### Illinois Tollway Base Sheet Revisions

Drawing	Modification Summary	Effective: 03-01-20
Diawing	Modification Summary	Lifective: 03-01-20
	Plaza Electrical Work (Business System)	-Series 2500
	, , , , , , , , , , , , , , , , , , ,	,
M-BUS- 2503	Single Line Power Diagram	
	Removed reference to air compressor: VES Wash cabinitrogen generator.	·
	Revised to one UPS per plaza building to provide emer equipment.	gency power to IT, ITS and Tol
M-BUS- 2505	Fiber Interconnections Between Main and Remote Plazas	
	Added Watch Dog camera to security camera identifica	tion.
	Added identification for MTS-1 manual transfer switch a	
M-BUS- 2509	Exterior Elevations - Main Plaza	
Choot 1	Added the air terminal (lighting rods) on roof of plaza bu	uilding.

**MECHANICAL PLAN - MAIN** PLAZA

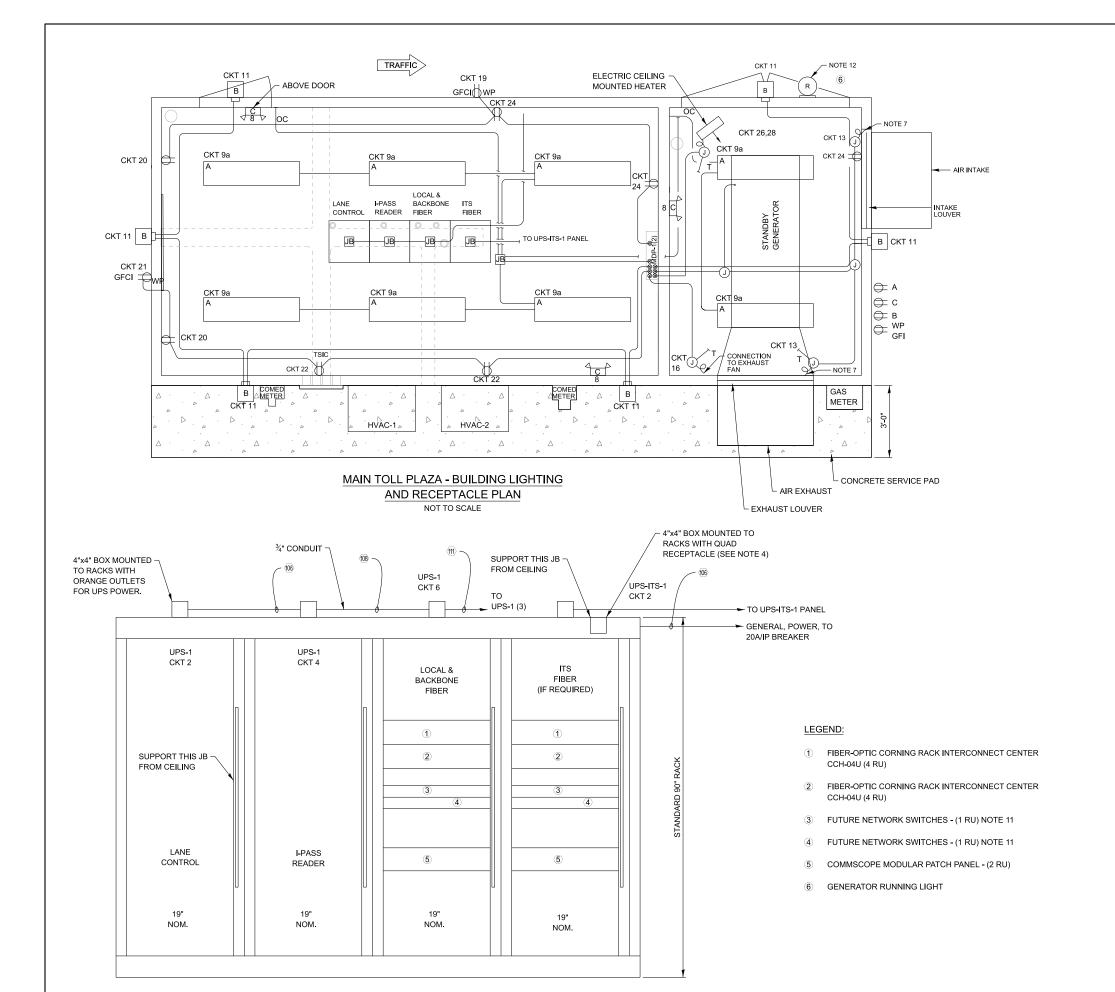
Sheet 1	Added note to designer: "Air terminal rods are to be inst	talled and fixed to roof"
Sheet 2	Added exterior wall and roof details	
M-BUS- 2512	Mechanical Plan - Main Plaza	
	Updated details of Manual Transfer Switch MTS-1 and	MTS-2.
	Revised HVAC-01 and HVAC-02 model number for nev	v refrigerant gas in BARD HVA
M-BUS- 2514	Control Building Grounding Details - Main Plaza

VERSION: BASE SHEET:
2025-03 M-BUS-2514

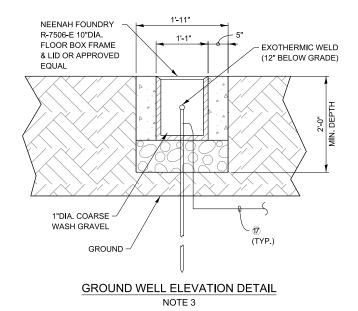
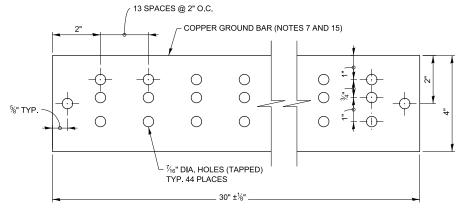
Sheet 1	Rearranged the original M-BUS-2514 to keep layout on to Sheet 2 for clarity	-
Sheet i	Added details for facility grounding of lighting protection grounding triad loop	system to improve efficiency o

Sheet 2	Moved grounding details from original M-BUS-2514 to t	his Sheet 2 for clarity
M-BUS- 2515	Panelboard Schedules - Main Plaza	
	Convert breaker #31 from Air Compressor to Spare.	
	Convert breaker #37 from Line Conditioner to Spare.	
	Convert breakers #30 and #32 Line Conditioner to UPS	S-1 (Tolling).
	Convert breaker #2 from UPS-1 to Spare.	
	For Panel UPS-1 change voltage to 120V/208V, change to 60A.	e phase/wire to 1/3, change bus
M-BUS- 2516	Video Power Junction Box Detail - Main Plaza	
	1	
	Added option for four power supplies (one per VES can	nera to connect).

LOOP PLAN - AET 3-LANE LAYOUT

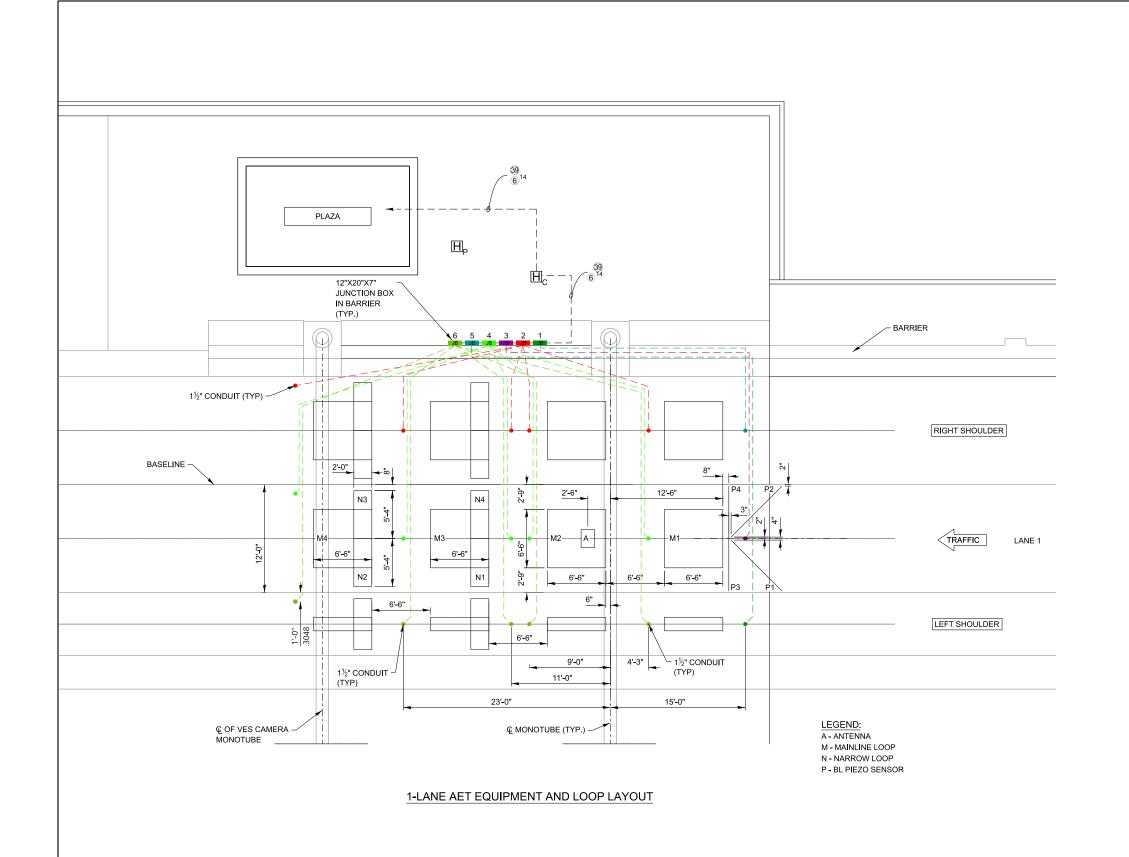
···· -	<b>——</b>
Drawing	Modification Summary	Effective: 03-01-202
	Plana Flactrical Wards (Pusinger Contant)	Caria a 0500
	Plaza Electrical Work (Business System)	-Series 2500
M-BUS-		
2518A	Loop Plan - AET 3-Lane Layout	
	Revised representation of pavement marking as solid lin	nes and no RRPM within the limi
	the CRC pavement.	la a a
	Revised details of the piezo sensors and loops in each	
	Added Legend for antennas, mainline loops, narrow loo	ps and piezo sensors.
M-BUS-		
2518B	Loop Plan - AET 1-Lane Layout	
	Added Legend for antennas, mainline loops, narrow loo	ps and piezo sensors.
	Revised details of the piezo sensors and loops in each	lane.
M-BUS- 2518C	Loop Plan - AET 1-Lane Layout Single Monotube	
	Created details for single monotube with loops and piez	o sensors.
	Added mounting details of the junction box at the top of	the vertical section of the monot
	Added routing of the conduit for VES wash tubing .

VERSION: BASE SHEET:
2025-03 M-BUS-2518D

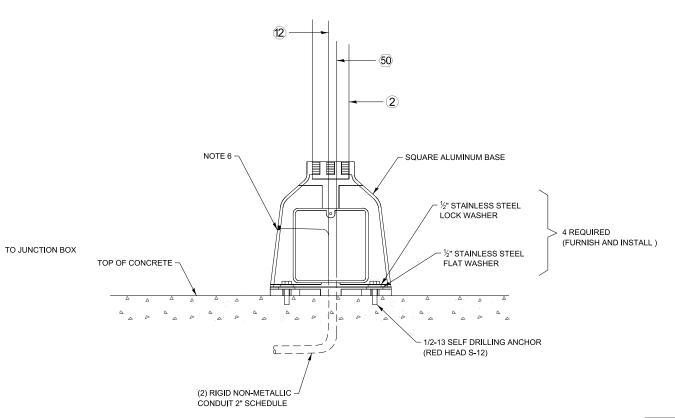
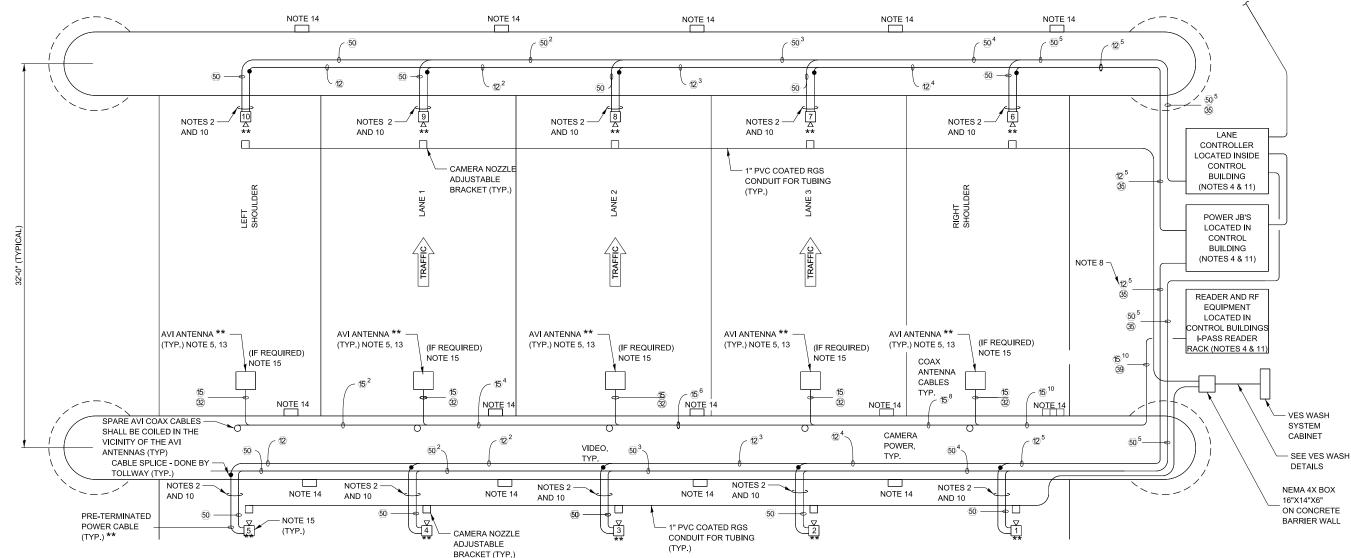
Add details for VES wash tubing cut-out.	
M-BUS- 2518D	Ground Mounted VES Camera with VES Wash Tubing	
	Added details for ground mounted VES cameras on peo	
	Added mounting details to attach the conduit for VES W	ash tubing to the VES camera
	pedestal.	
M-BUS-		
2520	Exterior Elevations - Remote Plaza	
	Added the air terminal (lighting rods) on roof of plaza bu	
	Added note to designer for lighting rods on top of the bu	ıilding
M-BUS- 2523	Mechanical Plan - Remote Plaza	
LULU	Revised HVAC-01 and HVAC-02 model number for ne	w refrigerant gas in BARD HVAC
M-BUS- 2526	Panelboard Schedules- Remote Plaza AET Lanes	
	Convert breakers #25 and #27 to Spare.	
	Convert breakers #30 and #32 to UPS-2 spare.	
	Convert breaker #36 to Spare.	
	Change voltage on UPS-2 panelboard to 120V/208V.	
	Change phase/wire to 1/3.	
	Change bus rating to 60A.	
	Change mains to 30A, 2P, MCB.

VERSION: BASE SHEET:
2025-03 M-BUS-2527

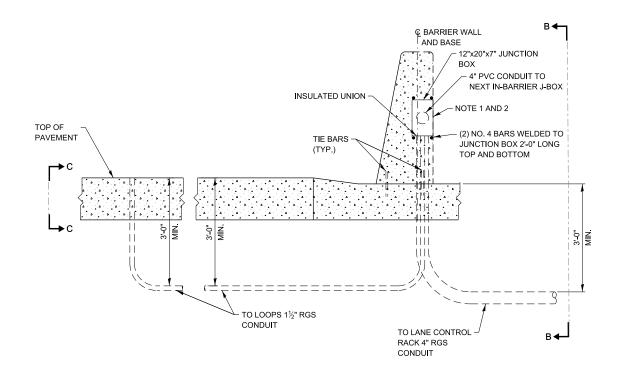
Base Shee	et Drawings			
Drawing	Modification Summary	Effective: 03-01-2025		
Plaza Electrical Work (Business System)-Series 2500				
M-BUS- 2527	Video Power Junction Box Detail - Remote Plaza			
	Added option for four power supply (one per VES ca	mera to connect).		
	Added air vents to enclosure.			
M-BUS- 2536A	Overhead Conduit Tray			
	Revised layout to show details of mounting provision assembly required.	s for the cable tray with all the parts and		
	Added note to designer: " All values designated "X" a			
	The old Note 1 was removed and Note 2 was renam been renamed Note 2	ed the new Note 1, the old Note 3 has		
M-BUS- 2536B	Overhead Conduit Tray			
23300	Part summary list was created and some notes revis	ed and added new notes		
	,			
M-BUS- 2538	VES Wash System Single Cabinet Detail			
	Revised layout of VES Wash single cabinet to position reservoir from the left side to the right side of the cab

M-BUS-2538

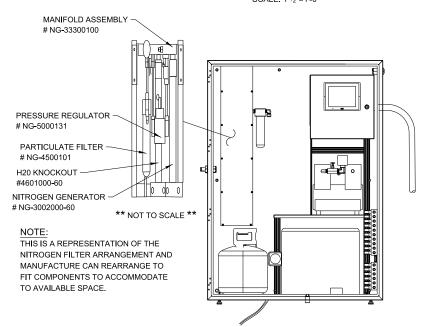
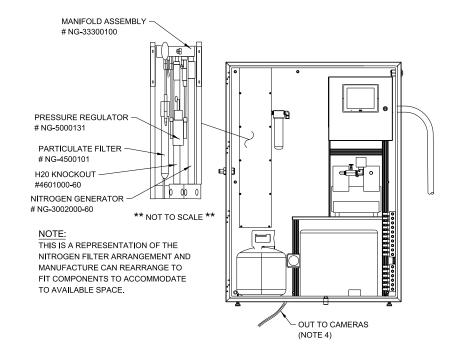
Remove exterior box for manual switches.			
	Revised assembly model number to: NS-GEN-SY-Y-	-0300		
	Revised Item A to be stainless steel enclosure.			
	Revised VES Wash cabinet manufacturer model nur	nber.		
	Expanded the Bil of Materials			
M-BUS- 2539	VES Wash System Panel Detail			
	Revised layout of the VES Wash cabinet to show two components	o front doors and rearranged of		
	Notes and layout revised of the VES Wash single ca	binet.		
	Revised assembly model number to: NS-GEN-SY-Y-			
	Revised part number for Liquid Tank: NG-ECD-0031			
	Model of the VES cabinet revised to 48" wide with tw HN4FM604818S16 NEMA 3R	-		
	Modified equipment layout to fit a bigger washing liqu	uid reservoir		
M-BUS- 2540	VES Wash System Flow Diagram and System			
	Revised Bill of Material spreadsheet			
	Revised several notes			
	Inlet valves details removed			
	Remove details for external switches
